## Product Advisory

Change of cover tape material

AFBR-S4P11P011R

AFBR-S4P11P012R

Current	New

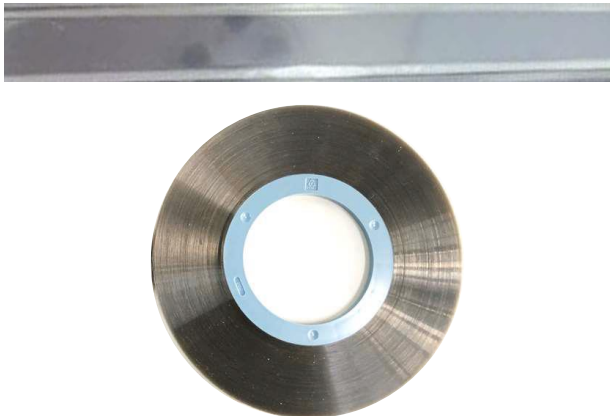
Introduction of new cover tape with similar appearance, which will replace the current cover tape for the tape and reel packaging.
